SUBJECT: BYRON AND BRAIDWOOD - ISSUANCE OF AMENDMENTS ON SPENT FUEL STORAGE RACKS (TAC NOS. MA5150, MA5149, MA5070, AND MA5071)

The amendments approve the installation of new Boral high density spent fuel storage racks at Byron and Braidwood stations. The amendments also approve an increase in the spent fuel pool storage capacity from 2,870 assemblies to 2,984 assemblies at each station.

ATTACHMENT TO LICENSE AMENDMENT NOS. 112 AND 112

SAFETY EVALUATION BY THE OFFICE OF NUCLEAR REACTOR REGULATION
RELATED TO AMENDMENT NO. 112 TO FACILITY OPERATING LICENSE NO. NPF-37,
AMENDMENT NO. 112 TO FACILITY OPERATING LICENSE NO. NPF-66,
AMENDMENT NO. 105 TO FACILITY OPERATING LICENSE NO. NPF-72,
AND AMENDMENT NO. 105 TO FACILITY OPERATING LICENSE NO. NPF-77
COMMONWEALTH EDISON COMPANY
BYRON STATION, UNIT NOS. 1 AND 2
BRAIDWOOD STATION, UNIT NOS. 1 AND 2
DOCKET NOS. STN 50-454, STN 50-455, STN 50-456, AND STN 50-457

Figure 3.7.16-1 (page 1 of 1)
Region 2 All Cell Configuration Burnup Credit Requirements
(Joseph Oat Spent Fuel Pool Storage Racks)

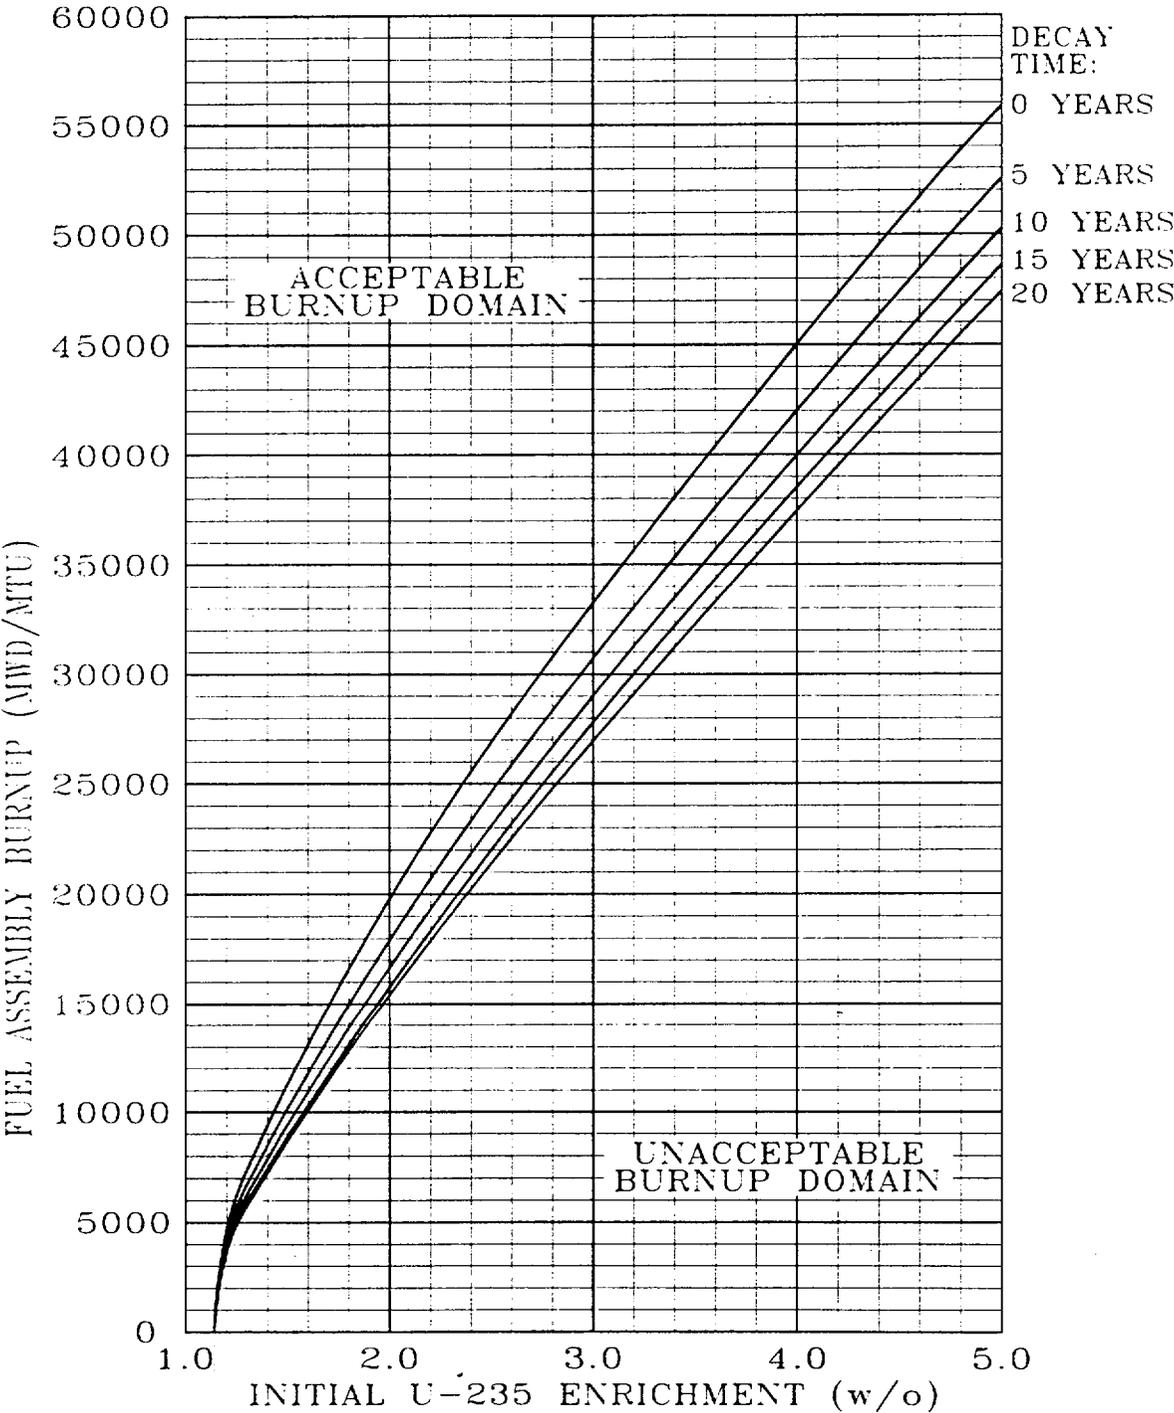
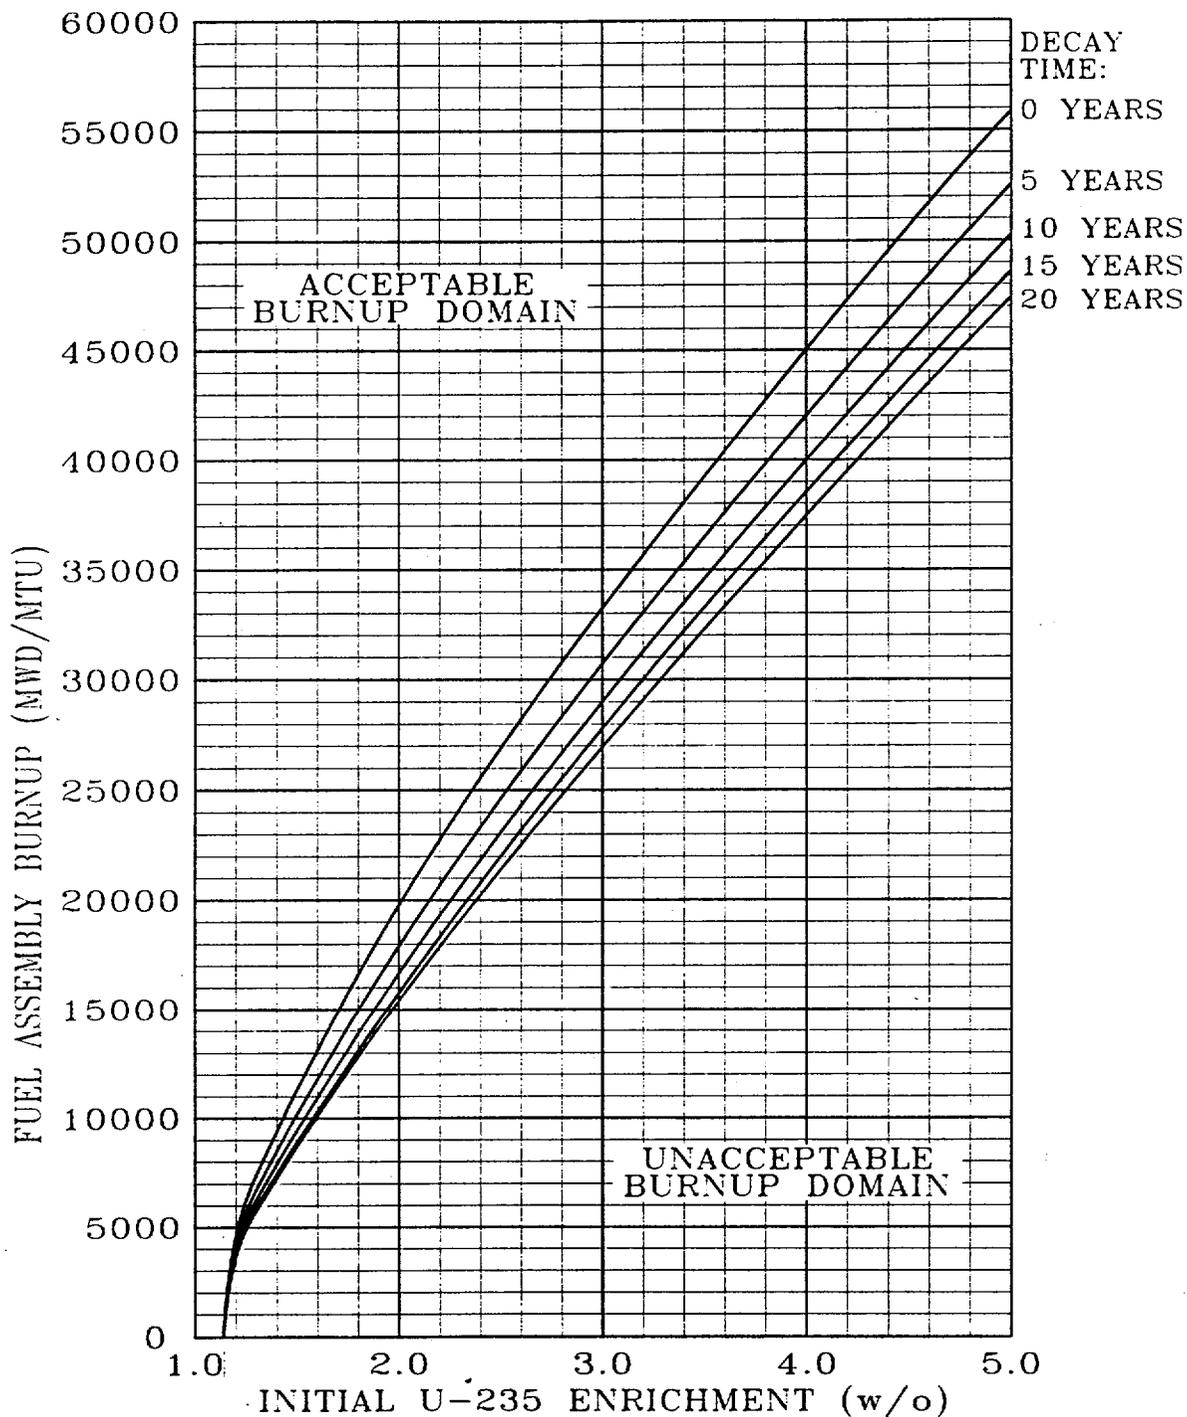
- b. Region 2 of Joseph Oat spent fuel pool storage racks
Have a combination of initial enrichment, burnup, and decay time within the Acceptable Burnup Domain of Figure 3.7.16-1, 3.7.16-2, or 3.7.16-3, as applicable for that storage configuration.

Figure 3.7.16-4 (page 1 of 1)
Region 2 Fuel Assembly Burnup Requirements
(Holtec Spent Fuel Pool Storage Racks)

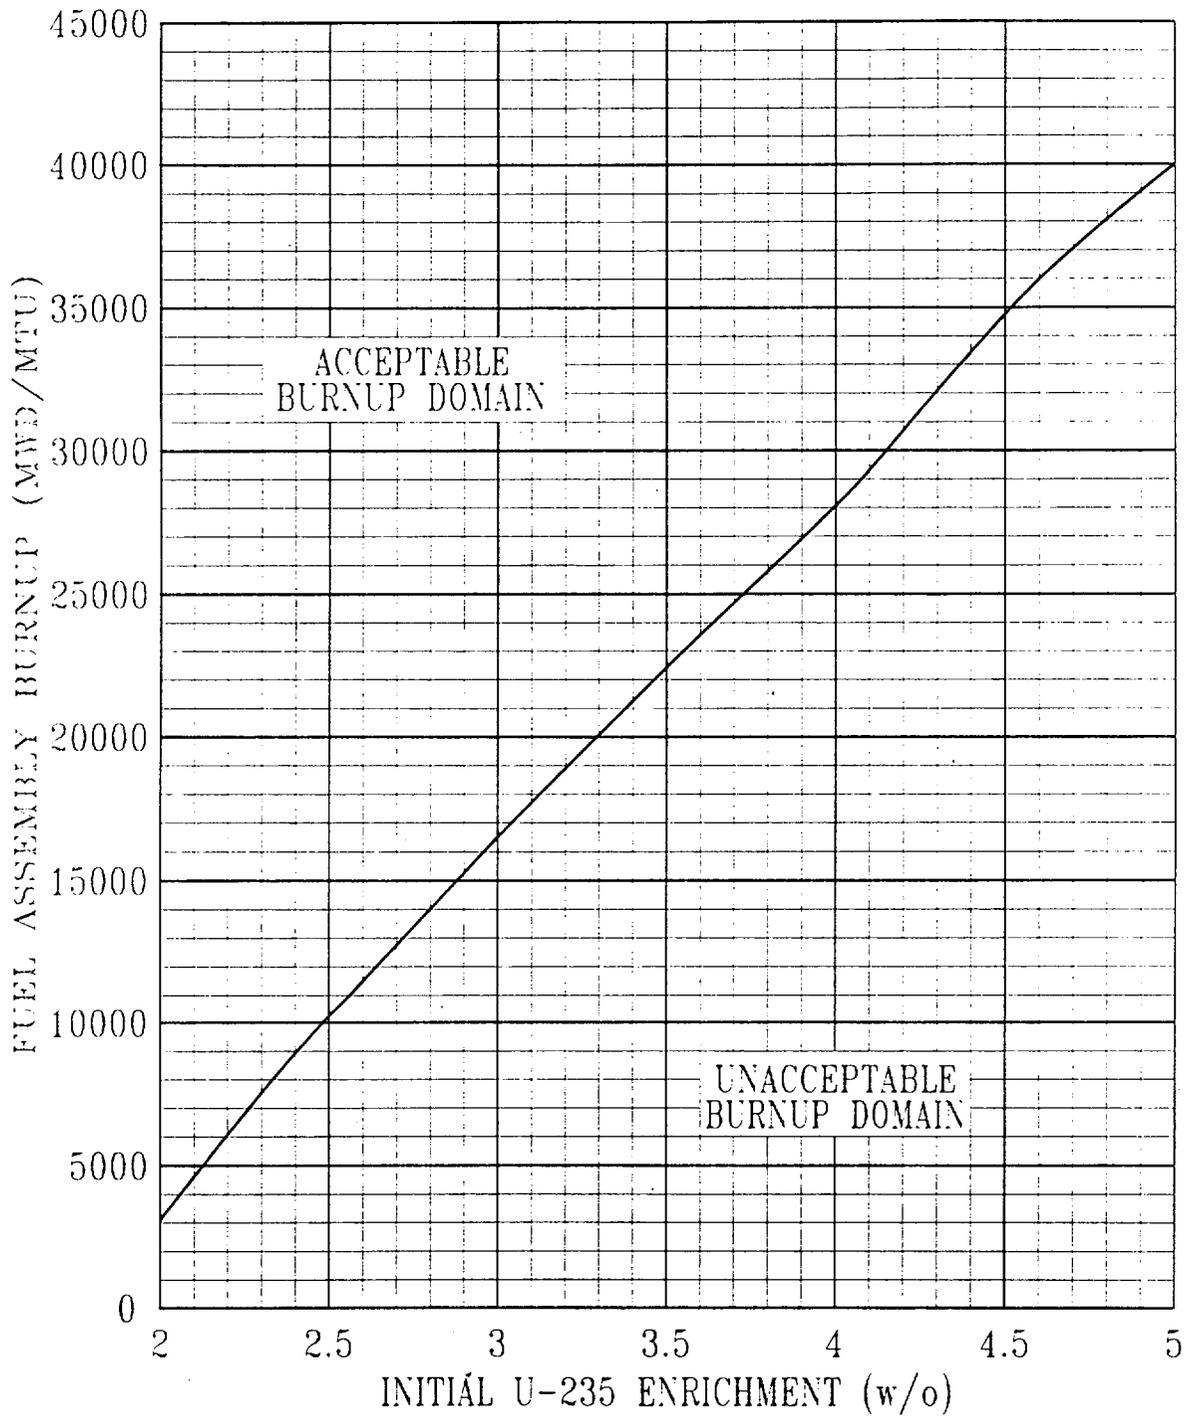
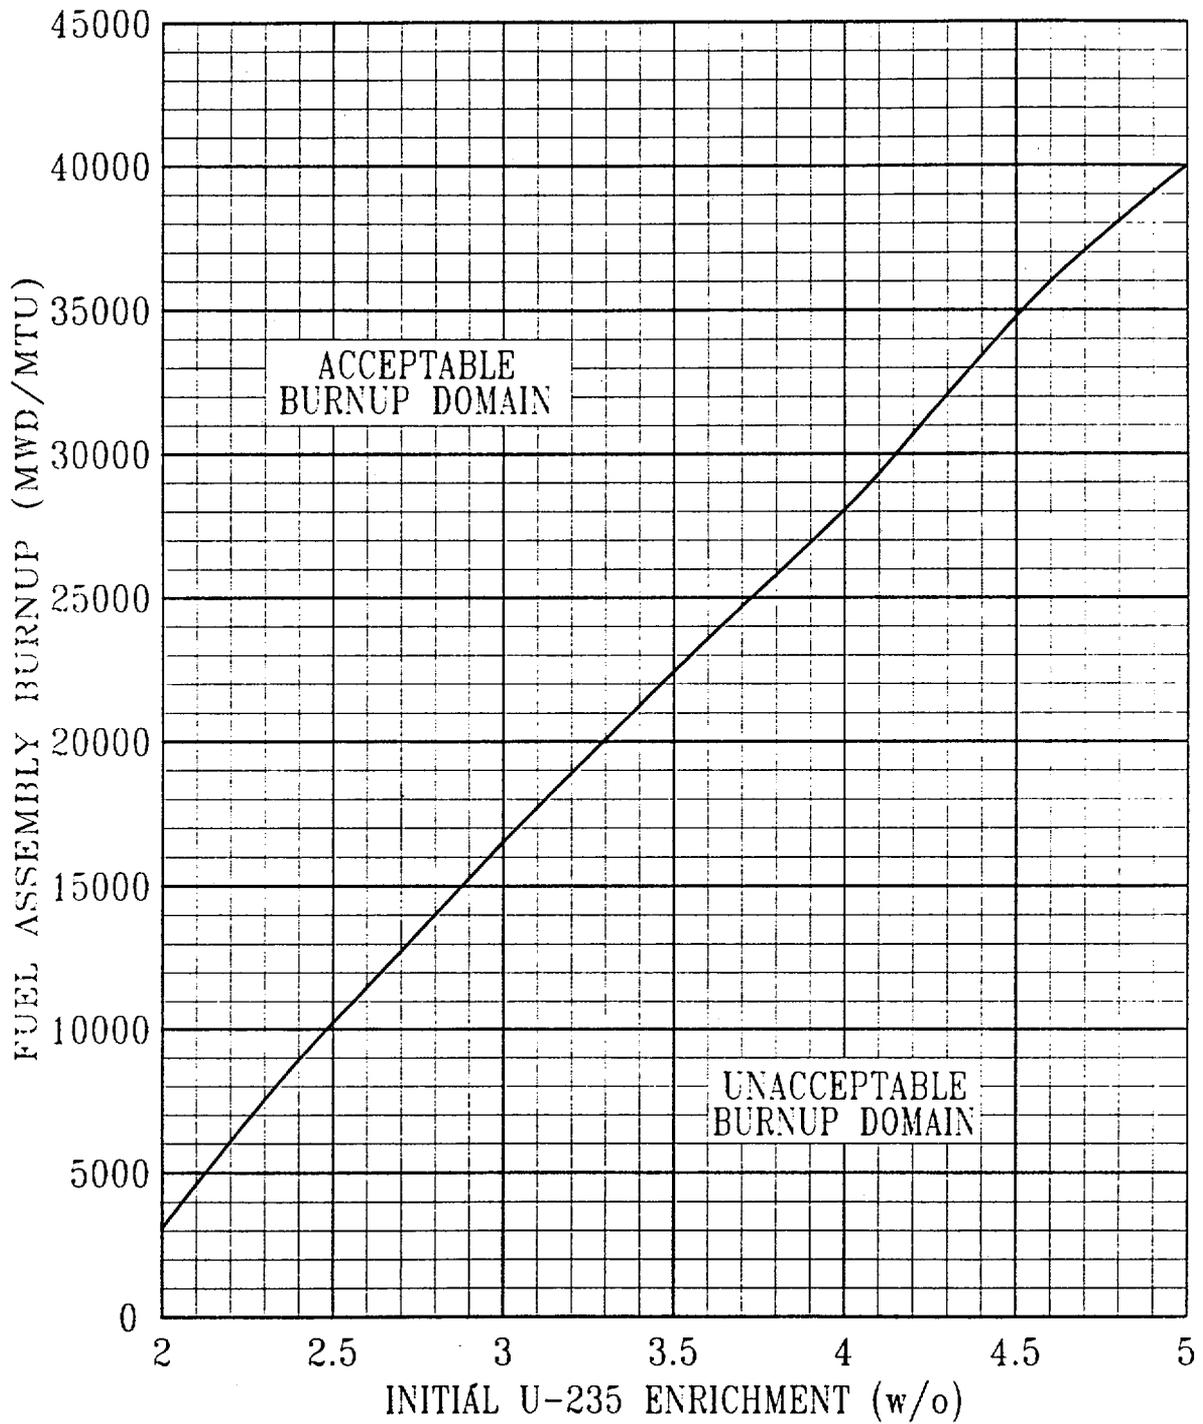
- e. Region 2 of Holtec spent fuel pool storage racks
Have a combination of initial enrichment and burnup within the Acceptable Burnup Domain of Figure 3.7.16-4.

The results of these analyses, using the acceptable methods discussed above, meet the NRC criterion of k_{eff} no greater than 0.95, including all uncertainties at the 95/95 probability/confidence level, and are, therefore, acceptable. The results show that Region 1 can accommodate fuel with enrichment as high as 5.0 w/o U-235 without restriction. Storage of fuel assemblies in Region 2 requires fuel burnup as a function of initial enrichment as given in TS Figure 3.7.16-4.

burnup and enrichment combination outside of the acceptable areas in TS Figure 3.7.16-4, which could lead to an increase in reactivity. For such events, credit may be taken for the presence of at least 300 ppm of soluble boron in the pool required by TS 3.7.15 for the Holtec racks, since the staff does not require the assumption of two unlikely, independent, concurrent events to ensure protection against a criticality accident (double contingency principle). The reduction in k_{eff} caused by the boron more than offsets the reactivity addition caused by credible accidents. In fact, calculations show that for the most severe accident condition, a soluble boron concentration of 220 ppm boron would be adequate to maintain k_{eff} less than 0.95 for the Holtec racks.
